Don Davis, RRC/RWC/REWC/RBEC
Senior Field Engineer/Principal
Wetherholt and Associates, Inc.

Please note that this memo is provided at the request of Pike Place Market PDA. No liability, warranty of merchantability, or guarantee of roofing, waterproofing, or building envelope service life is accepted or implied. Wetherholt and Associates, Inc., is a neutral roofing, waterproofing, and building envelope consulting firm specializing in resolving building envelope and moisture related issues.

Figure 3. Suggested waterproofing detail showing waterproofing extending above topping slab onto sheathing behind stucco, covered with stainless steel flashing.

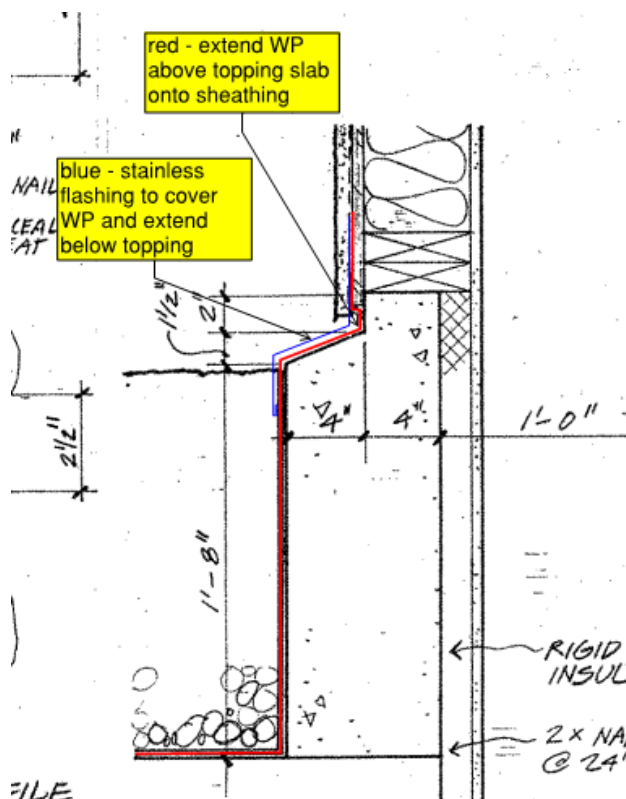
At the perimeter edges of the plaza, there should be a concrete curb to form a bathtub to turn waterproofing up against. Detail 23 (Figure 2) shows the framed wall extended below the topping slab. This is poor construction practice and will result in deteriorated framing/sheathing once the waterproofing ages and no longer provides protection. This condition appears to be the cause of water under the floor of the Heritage House.

The edge of the slab should be constructed similar to Detail 23 (Figure 2), with a continuous concrete curb placed at the edge. In addition, waterproofing should extend up onto the framed wall and where exposed above topping slab should be covered with stainless steel flashing. See Figure 3, below.

It is suggested that the exterior walls of the plaza be temporarily shored, and concrete curbs installed. This work should be part of a re-waterproofing effort of the plaza, including removal of all overburden (topping slab, any insulation, and waterproofing), down to the structural slab. The repair could be performed at the perimeter of the plaza only, by removing approximately 3 feet of the topping slab, but we suspect the existing waterproofing is at the end of its useful life and likely requires full replacement.

Photograph 22:
Injection performed in the ceiling
of the food bank.

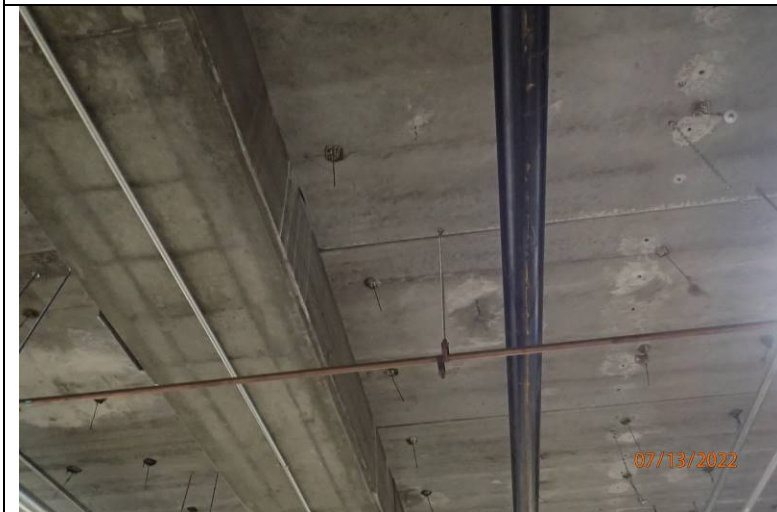
There is evidence of what appears to be epoxy injection in the ceiling of the food bank.
